I-4 Truck Parking Facilities (447724-1)

Value Engineering Study Final Report

FM Number: 447724-1

Project Description: I-4 Truck Parking Facilities

RECOMMENDATION No. 1: Centralize the Restrooms (Osceola County)

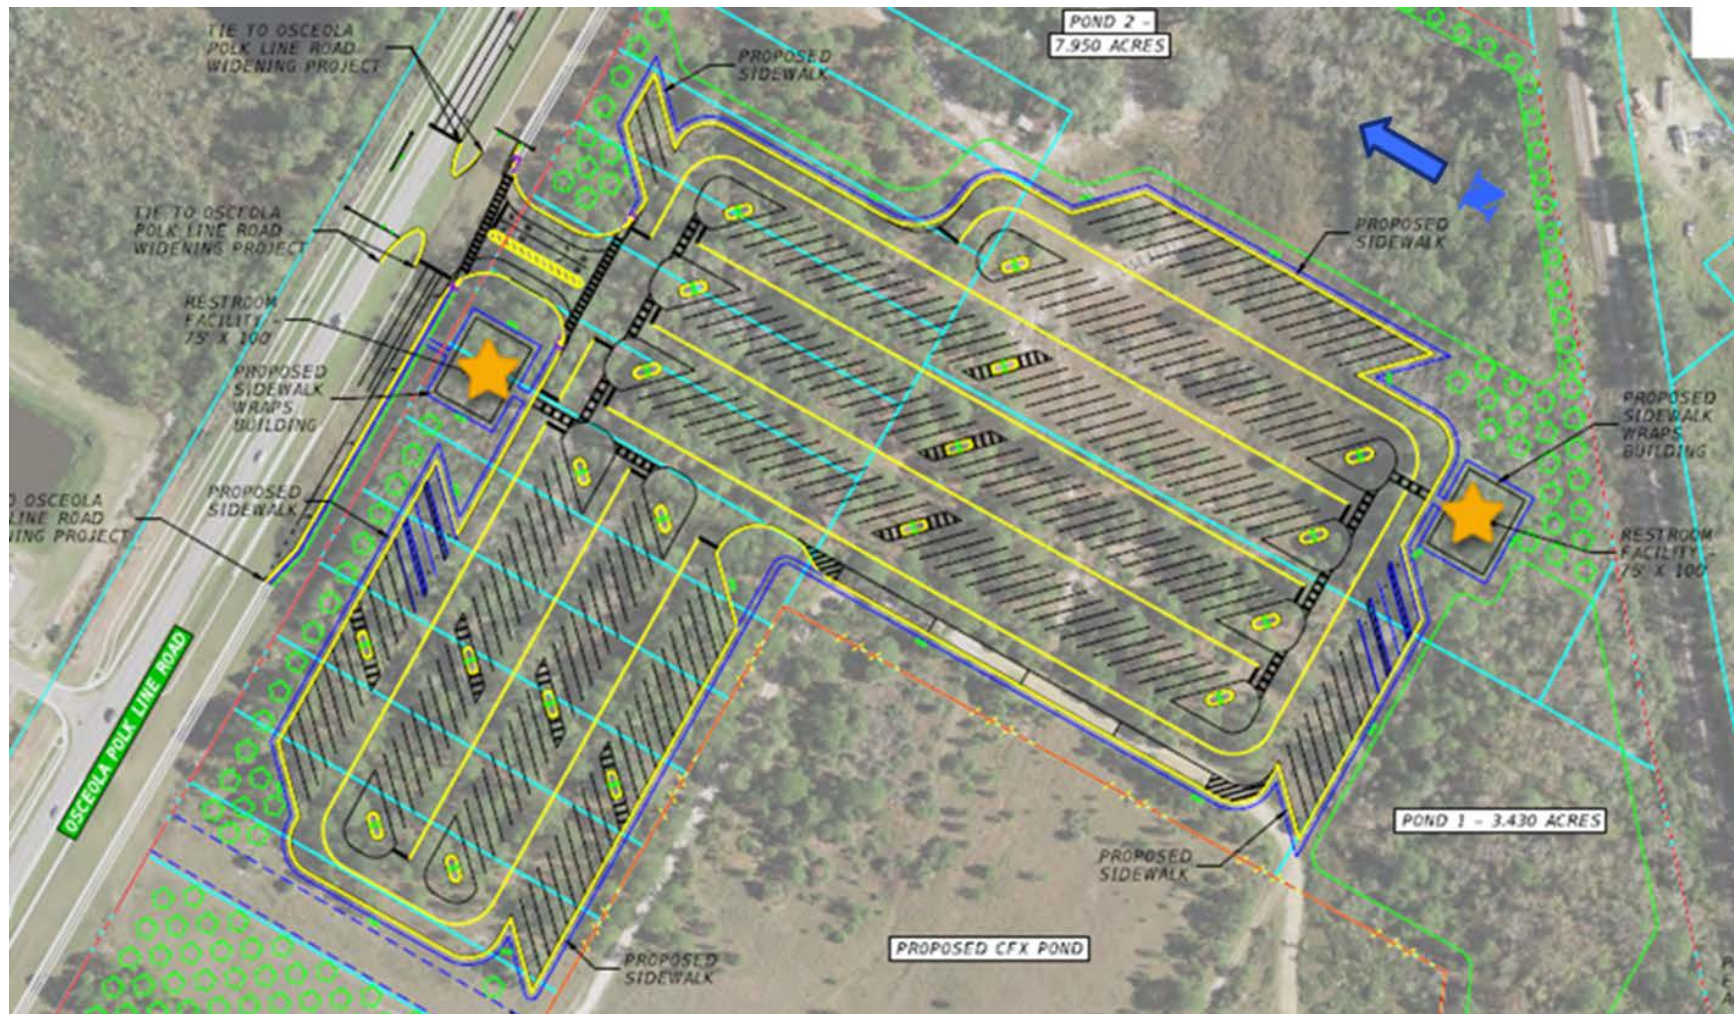
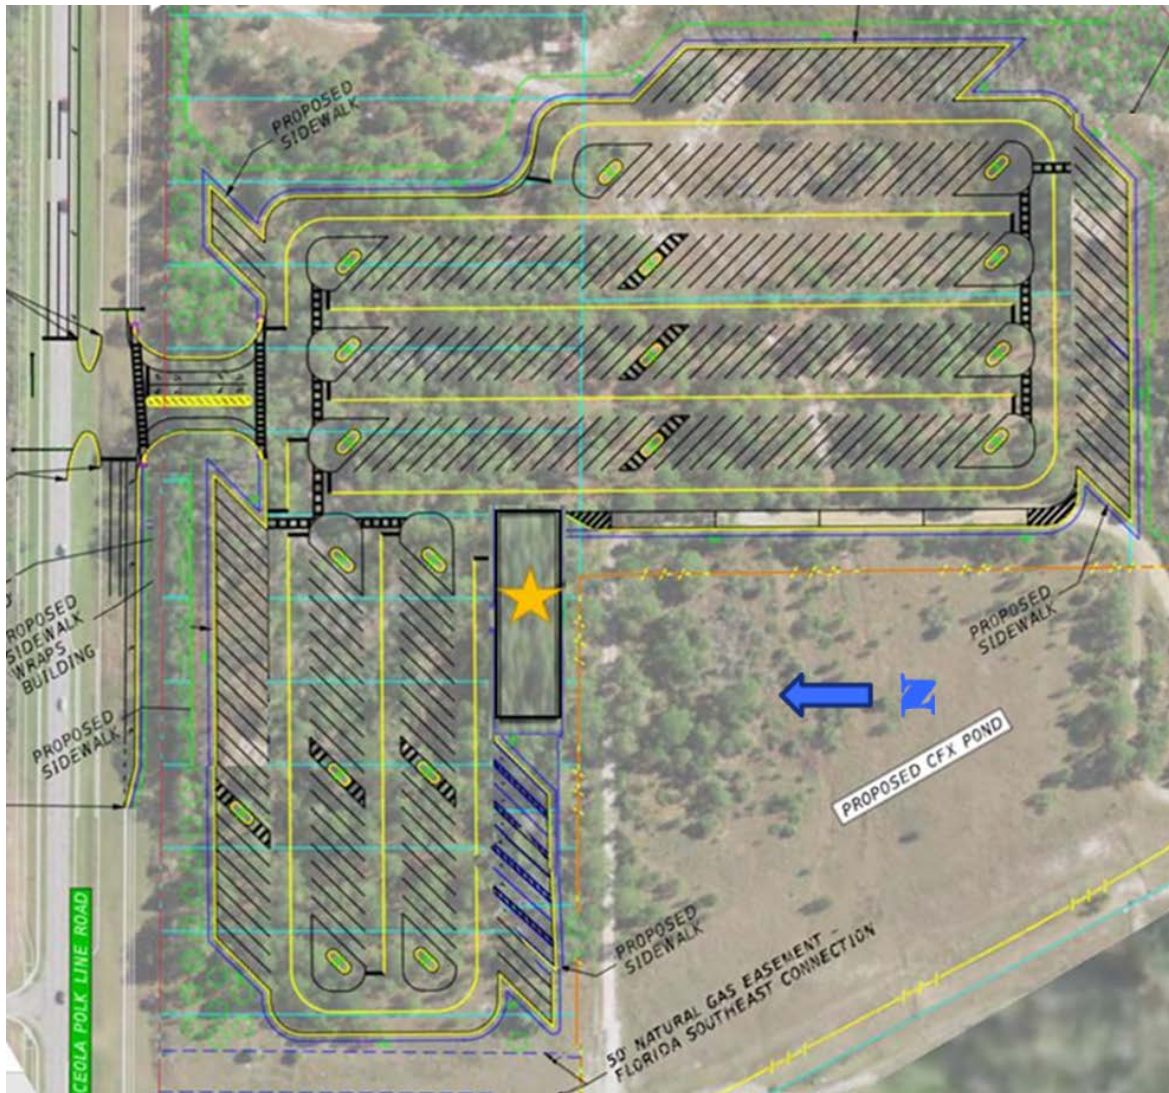
The PD&E Documents show two separate restroom facilities at either end of the sites at Osceola County and Volusia County Eastbound and Westbound.

The VE team recommends only having one large restroom facility in a centralized location at the Volusia County eastbound site. This can also add an additional row of truck parking spaces (44) to the north side of the site.

Response: Accepted

After developing a revised preliminary concept for Osceola County Site 1 with a centralized restroom, the PD&E study team determined that the number of parking spaces would remain constant at 230 parking spaces. Centralizing the restrooms centralizes the security area, reduces the utility and maintenance costs, and doesn't increase impervious surface area.

RECOMMENDATION No. 1: Centralize the Restrooms (Volusia County Westbound)

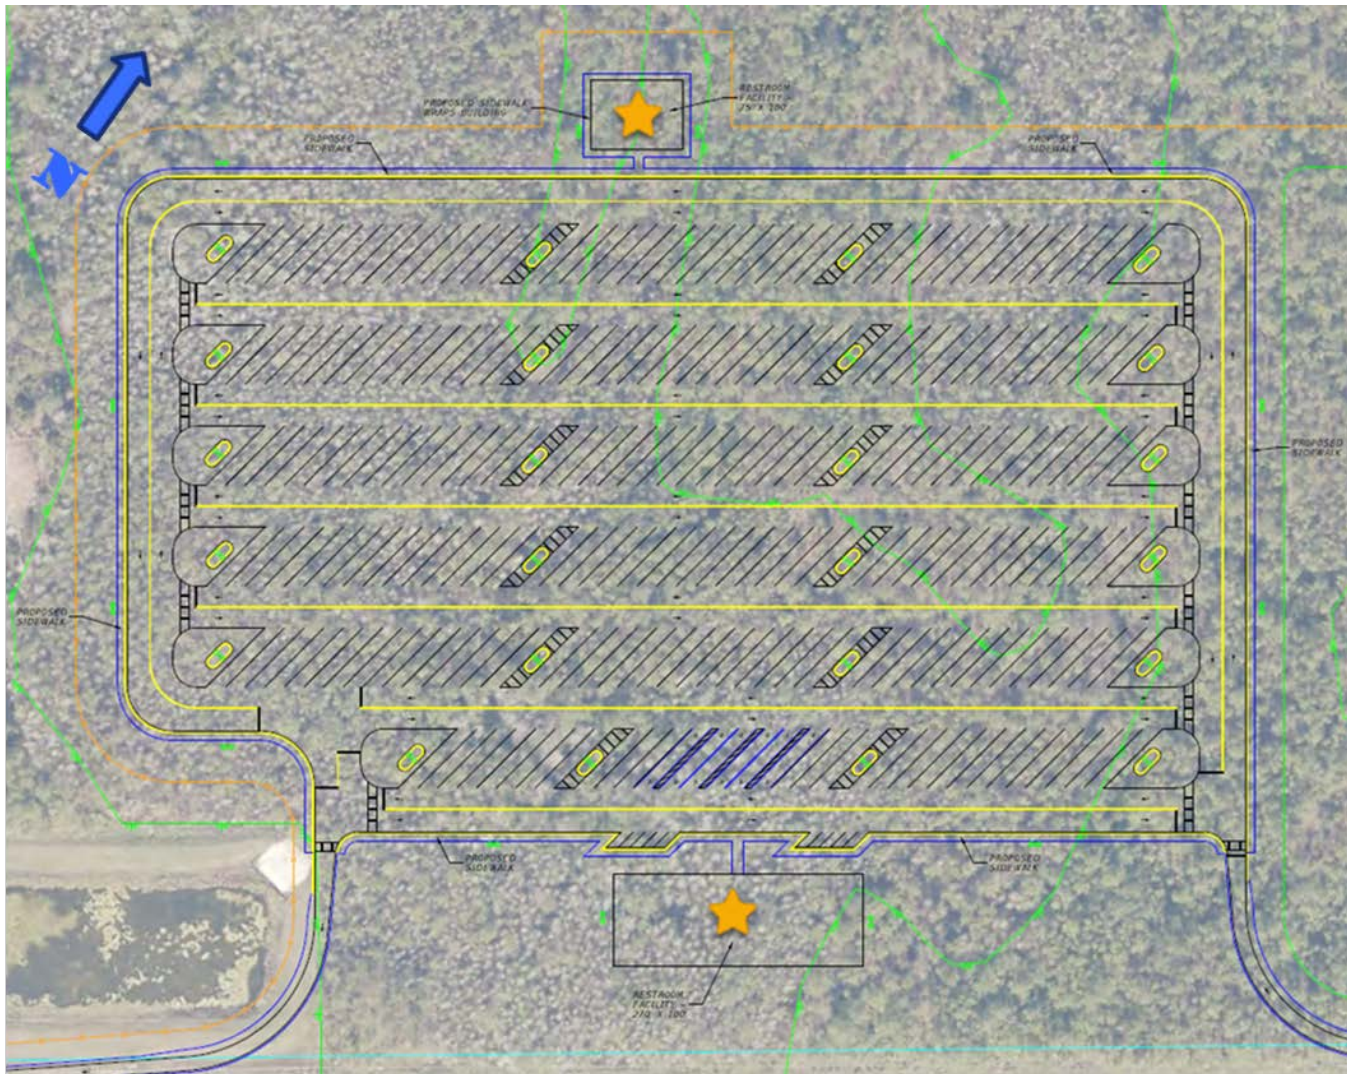
The VE team recommends only having one large restroom facility in a centralized location at the Volusia County westbound site. Also, adds an additional row of truck parking spaces (44) to the North. Building is being centralized would remove 20 spaces. Therefore, there is a net of 24 additional parking spaces.

Response: Accepted

After developing a revised preliminary concept for Volusia County Site 1B with a centralized restroom, the PD&E study team determined that the number of parking spaces would increase from 253 to 267 parking spaces. Centralizing the restrooms centralizes the security area and allows for just a single utility connection to the site, however it does minimally increase the total site impervious area. Two rows will

RECOMMENDATION No. 3: Reconfigure the middle aisles of the parking spaces with one-way circulation

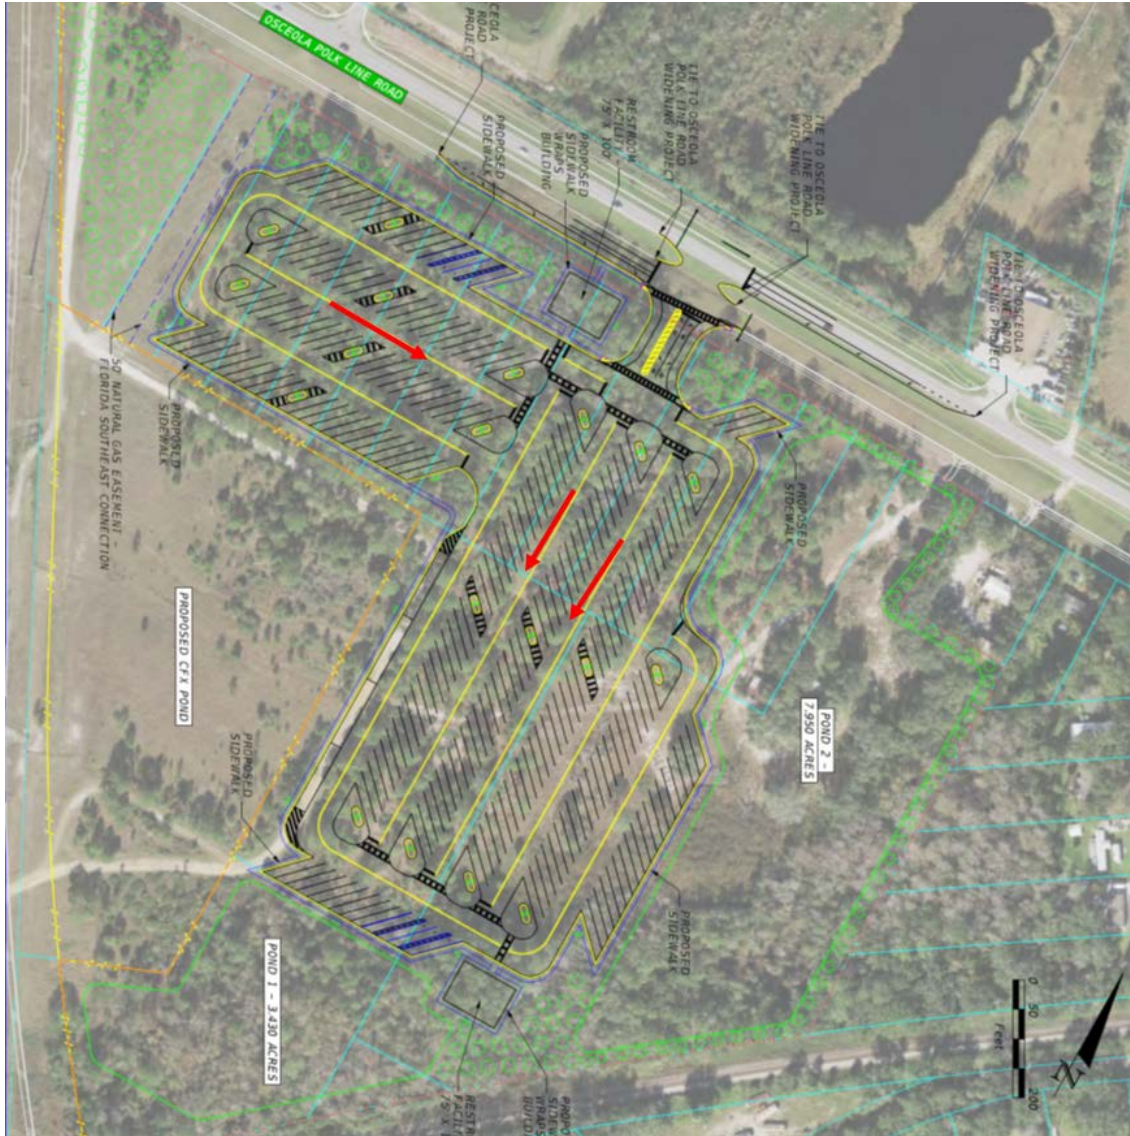
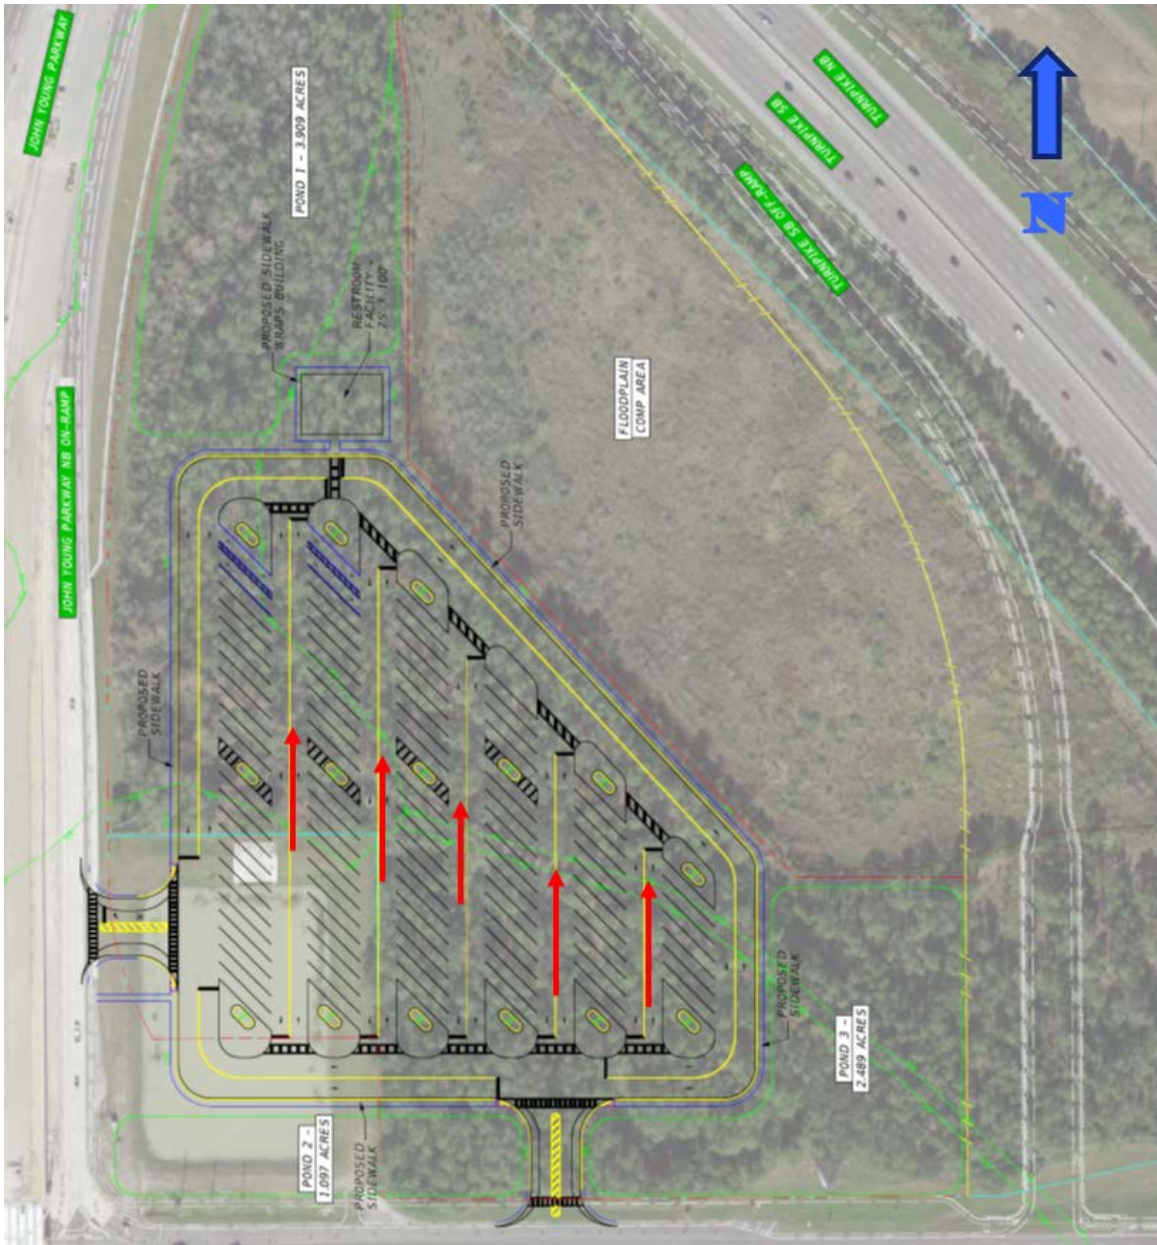
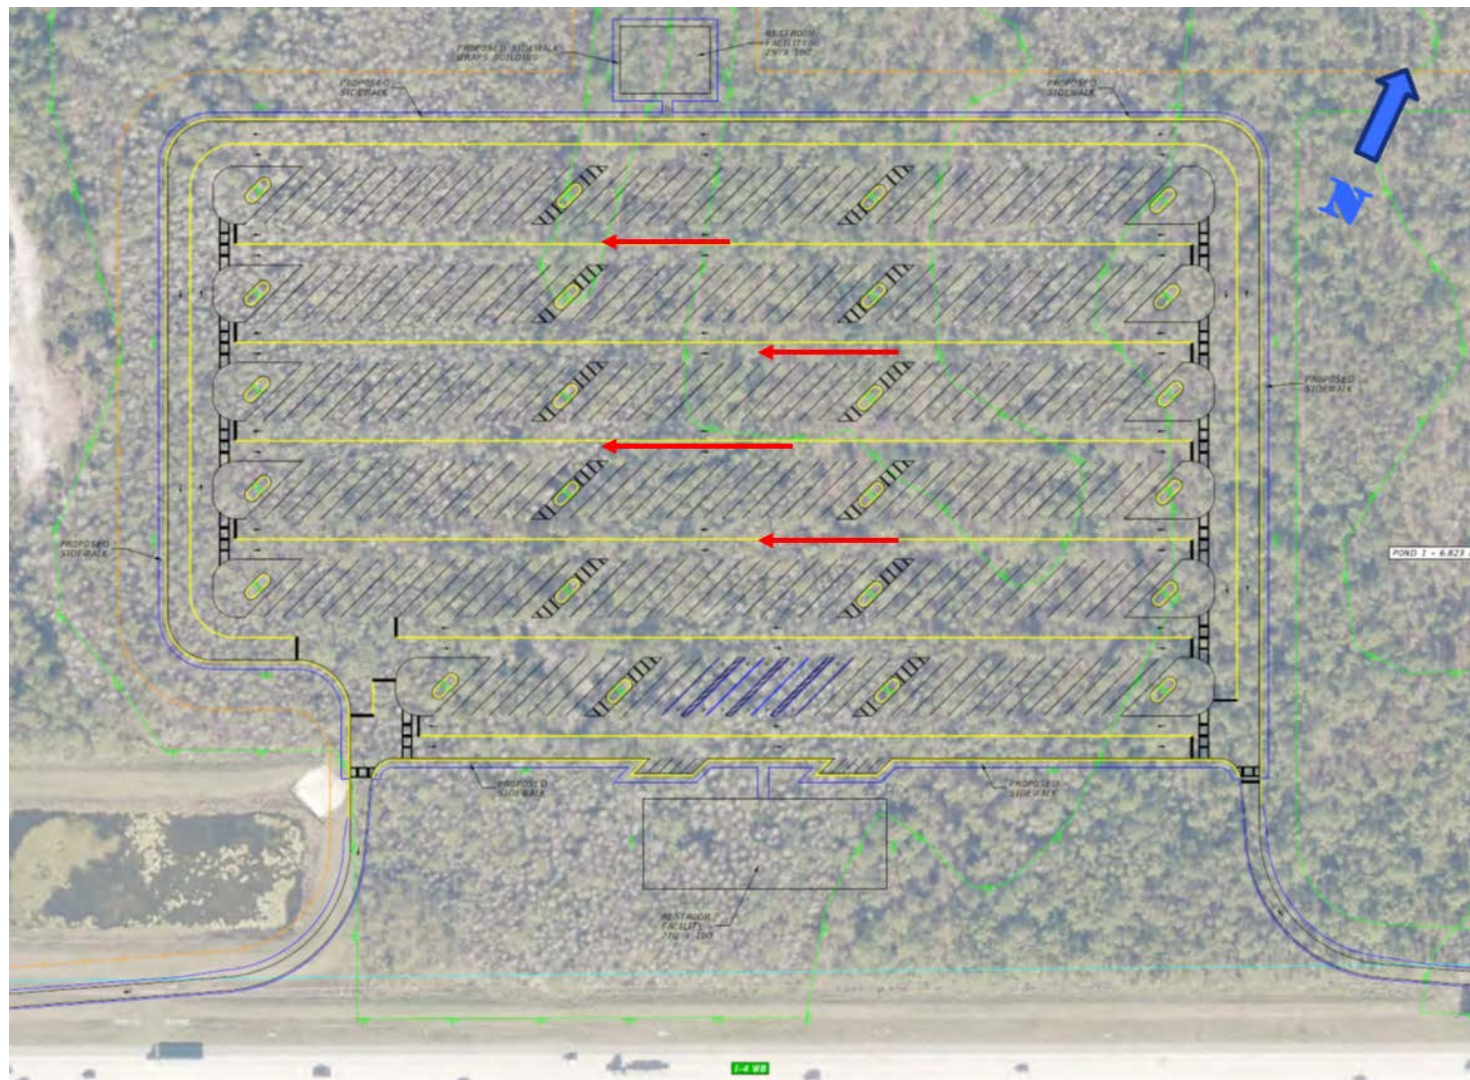
The PD&E Documents show the site configuration for all parking facilities with multiple two-way aisles for single parking spaces set at a 45° angle relative to the drive aisle. The current two-way aisles are set currently at forty-five (45) feet in width, twenty-two and a half (22.5) feet per direction. The aisles are available for either pull-in or back in based on the current configuration. The outer circulation lanes around the site have a total width of fifty (50) feet.

Response: Not Accepted

Similar to VE Recommendation 3A, the VE Recommendation is for the internal aisles in this site to be one-way aisles with the parking spaces oriented in a manner to promote same direction of travel, while maintaining pull-through parking. For the same reasons outlined in the Response to VE

VE Resolution: *This recommendation was **not accepted**. FDOT prefers to provide more flexibility and space in the aisles at the PD&E stage of project development.*

RECOMMENDATION No. 8A: Eliminate the John Young Parkway connection

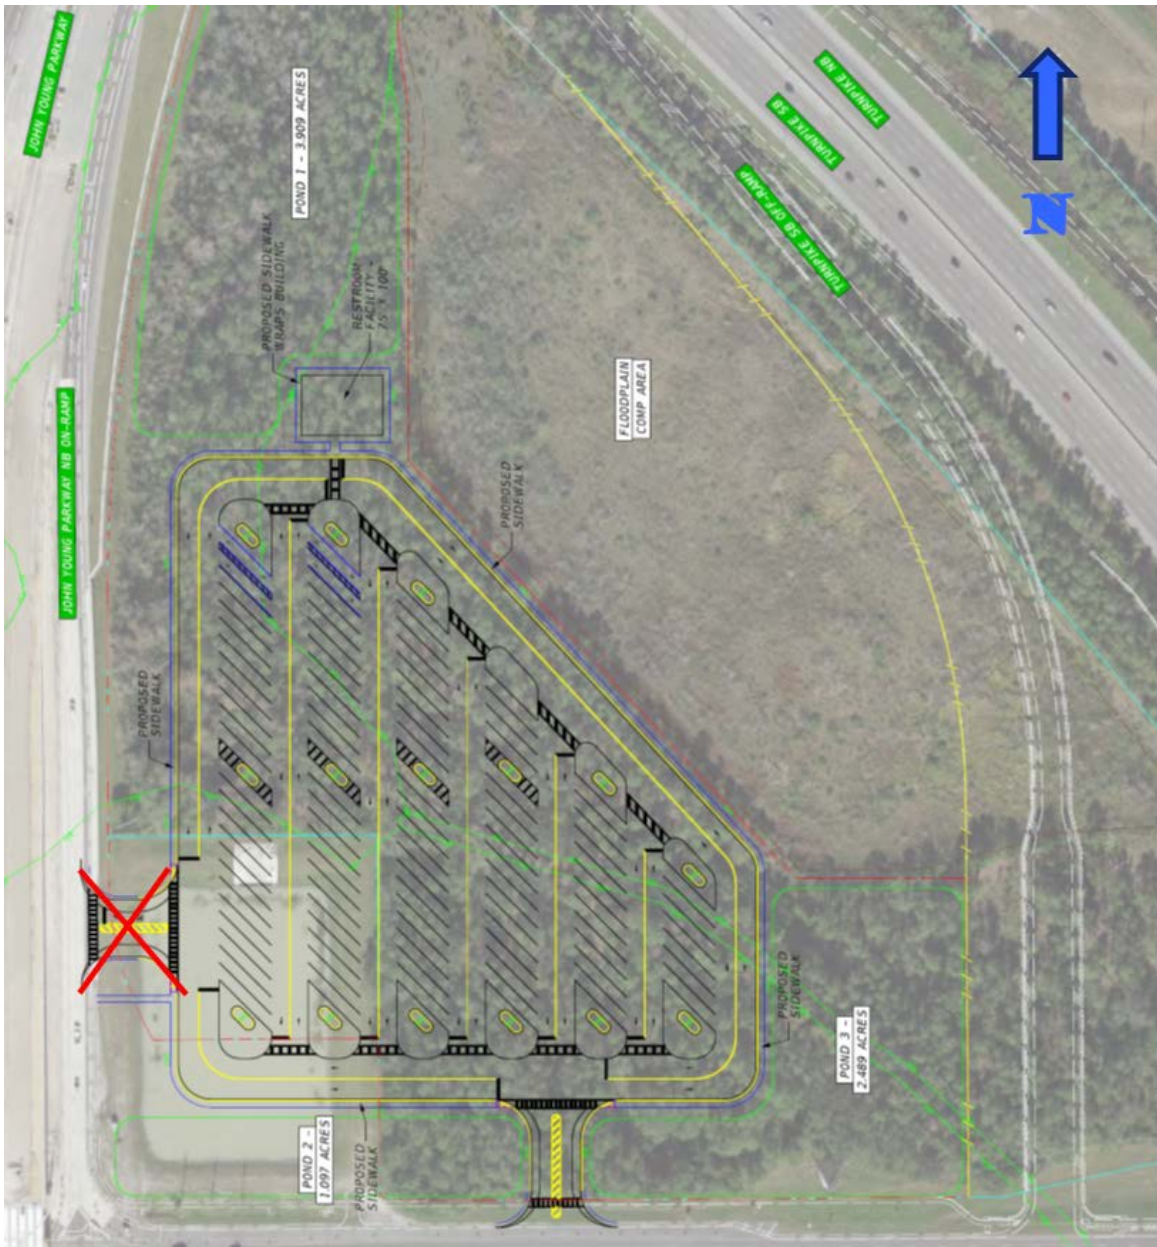
The PD&E Documents show ingress/egress on both John Young Parkway and Sand Lake Road.

Response: Not Accepted

Similar to VE Recommendation 3A, the VE Recommendation is for the internal aisles in this site to be one-way aisles with the parking spaces oriented in a manner to promote same direction of travel, while maintaining pull-through parking. For the same reasons outlined in the Response to VE Recommendation 3A, the additional flexibility in lane width is recommended for maneuverability to enhance safety for drivers and the VE recommendation is not accepted.

VE Resolution: *This recommendation was **not accepted**. FDOT prefers to provide more flexibility and space in the aisles at the PD&E stage of project development.*
